**Re: Comments on Oil and Gas Sector: Emission Standards for New and Modified Sources, Proposed Rule (Docket EPA-HQ-OAR-2010-0505)**

The Gas Processors Association (“GPA”) appreciates this opportunity to submit comments on the Environmental Protection Agency’s (“EPA’s”) proposed rulemaking “Oil and Gas Sector: Emission Standards for New and Modified Sources,” 80 Fed. Reg. 56,593 (Sept. 18, 2015) (“proposed rule” or “proposal”).

Figure 1:

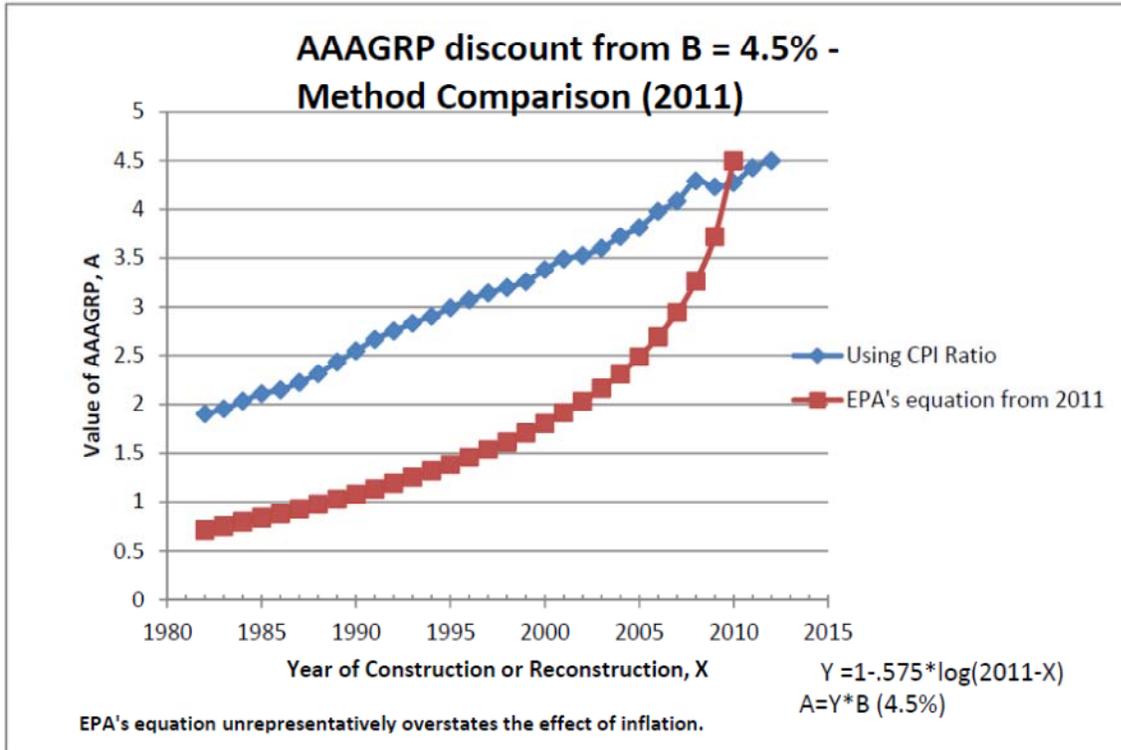
When changes are made at an existing facility, the component price data must be adjusted for inflation if it is not current. Attached as Figure 1 is a comparison of the two equations showing the value of A over time. The red curve uses EPA's proposed equation  $Y = 1 - 0.575 * \log(2011 - X)$ , and the blue curve uses GPA's proposed equation above using 2012 price data. A comparison of the two curves shows that the equation proposed by the EPA is no longer correlated with changes in the CPI and unrepresentatively overstates the effect of inflation in terms of discounting the value of B. In contrast Figure 2 is a comparison showing older data points using EPA's original equation and GPA's proposed equation. The red curve uses EPA's original equation  $Y = 1 - 0.575 * \log(1982 - X)$ , and the blue curve uses GPA's proposed equation above using 1982 as the date of component price data. In Figure 2, GPA's proposed equation tracks EPA's model very closely. This suggests that GPA's proposed equation does in fact capture EPA's original intent in establishing capital expenditure thresholds and should be used in lieu of EPA's proposed equation using 2011 as a starting point.
